UNITED STATES PATENT AND TRADEMARK OFFICE

APPLICATION NO.	FILING DATE	FIRST NAMED INVENTOR	ATTORNEY DOCKET NO.	CONFIRMATION NO.
09/176,580	10/21/1998	RAMESH SUNDARAM	S01.12-0460	2038

# Office Action Summary

## DETAILED ACTION

Fig. 13

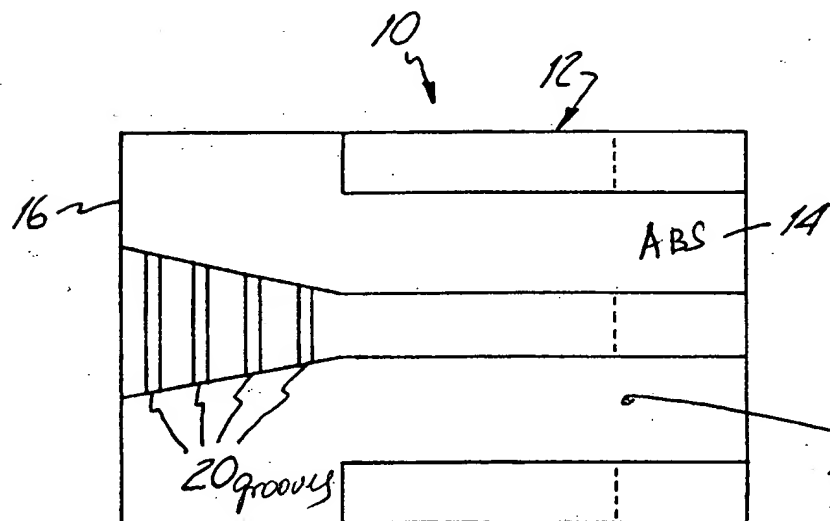
Boutaghou discloses in Figs. 1-4 and 13 a thermal asperity sensor comprising a slider body 12 having a leading edge A, transducers (magnetoresistive sensors/ MR) 18 spaced apart along the length of rails (elevated/ raised bearing surface) 26 of an air bearing surface 14 ABS (col. 6, lines 6-7 and Fig. 1). Each transducer has layers, thus, constituting a thin (having thickness/ height) flat (col. 7, line 20) asperity contacting surface (length) oriented along the ABS. As shown in Fig. 1, the transducers are oriented along (portion extending) the ABS. Inherently, the thickness of the transducer is intersecting (contacting) with its portion

extending along the ABS. (The numerals A- B have been added by the Examiner, see attachment to the Office Action).

shown in Figs. 1-4 and 13, the MR of Boutaghou inherently has a surface (contact) portion and a thickness portion (height) and contacts the ABS with the surface portion.
